**Before the Hearings Panel
At Wellington City Council**

In the matter of the Proposed Wellington City District Plan

**Hearing Stream 5 (Earthworks) Reporting Officer Right of Reply of
Hannah van Haren-Giles on behalf on Wellington City Council
Date: 28 August 2023**

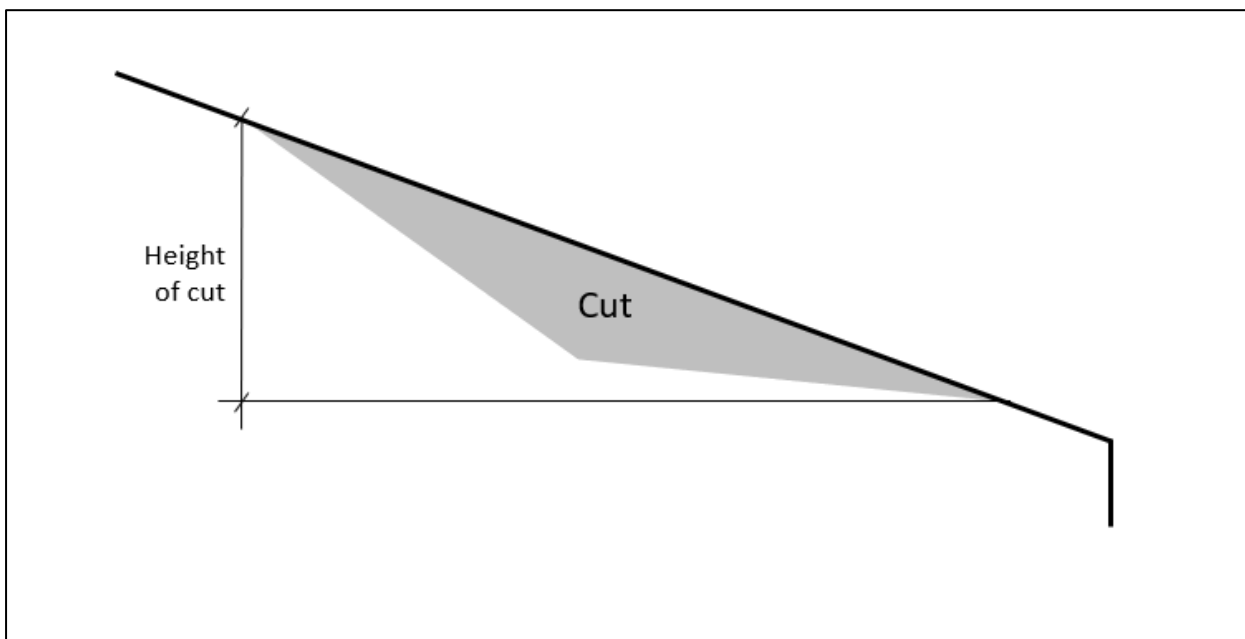
interpretation/application of the definition which the PDP definition seeks to resolve. In other words, the PDP definition seeks to retain but clarify the intent of the ODP definition and reflect current interpretation/application of 'cut height'. This will provide plan efficiency and clarity for both plan users and Council staff.

ODP definition	<i>means the maximum height of the earthworks cut at any time, measured vertically and includes any working cut height during the course of the earthworks.</i>
PDP definition	<i>means the maximum height of the cut at the completion of earthworks, measured vertically from the highest point at the top of the cut to the bottom of the cut.</i>

a. Cut height

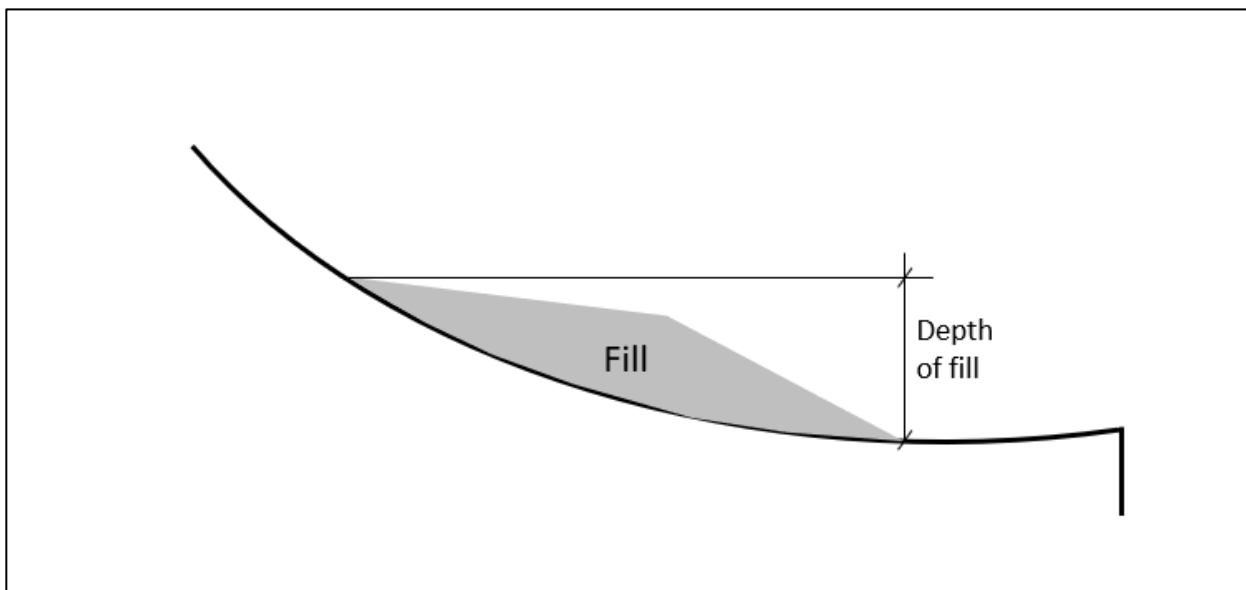
20. I note that there is a 'depth of fill' figure associated with the 'fill depth' definition in the ODP. Based on this diagram, the inverse measurement of cut height should be apparent – i.e. measured from the highest point of the cut to the bottom of the cut.

21. Through discussions with consents and compliance staff it has been suggested that a figure illustrating the 'cut height' definition would be beneficial to further aid clarity. I therefore recommend that diagrams illustrating cut height and fill depth be (re)introduced to support the PDP definitions, as follows:
